Access Compliance Report

Public Rights-of-Way

(Curb Ramps)

Intersection ID: 16545	Main Street: N_SHARON_AMITY_RD	Cross Street: MONROE_RD	Location: NE
ADA ID: 5B210900CF62	Ramp Type: Para	Initial Pass/Fail: Fail	Overall Compliance: No
Codes/Mitigation Info/Possible Solution		Field Measurements/Component Compliance	
Severity Score: 13.75

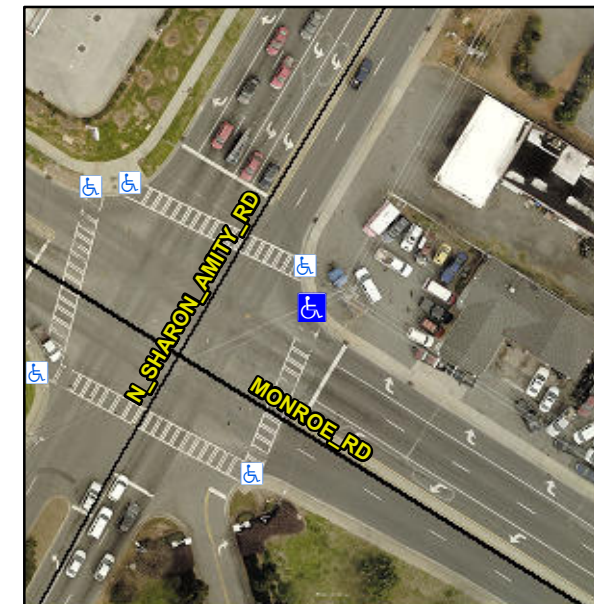
RT RP < 5%

R304.3.2, R304.5.3

Compliance	Description	Data	Compliance	Description	Data
N/A	Ramp Length LT (in)	62.0	N/A	Ramp Length RT (in)	60.5
Yes	Ramp Width LT (in)	59.0	Yes	Ramp Width RT (in)	61.0
No	Ramp Slope LT (%)	10.2	Yes	Ramp Slope RT (%)	2.1
No	Ramp XSlope LT (%)	3.2	No	Ramp XSlope RT (%)	3.3
N/A	Landing Length (in)	N/A	N/A	DWS Provided?	N/A
N/A	Landing Width (in)	N/A	N/A	DWS Contrast?	N/A
N/A	Landing Slope (%)	N/A	N/A	DWS Length (in)	N/A
N/A	Landing X Slope (%)	N/A	N/A	DWS Full Width?	N/A
N/A	Landing Curb? (Y/N)	N/A	N/A	DWS Offset (in)	N/A
N/A	Shared Landing?	N/A			
N/A	Gutter Ponding?	N/A	N/A	Gutter Slope (%)	N/A
N/A	Gutter Lip Ht (in)	N/A	N/A	Gutter X Slope (%)	N/A
N/A	Painted X Walk1?	Yes	N/A	Painted X Walk2?	N/A
	X Walk 1 Direction	To SW		X Walk 2 Direction	N/A
N/A	X Walk 1 Width (in)	112.0	N/A	X Walk 2 Width (in)	N/A
	X Walk 1 Slope (%)	2.9		X Walk 2 Slope (%)	N/A
	X Walk 1 X Slope (%)	2.7		X Walk 2 X Slope (%)	N/A
N/A	Ramp inside XWalk1?	Yes	N/A	Ramp inside XWalk2?	N/A

Remove & Replace Entire Ramp.
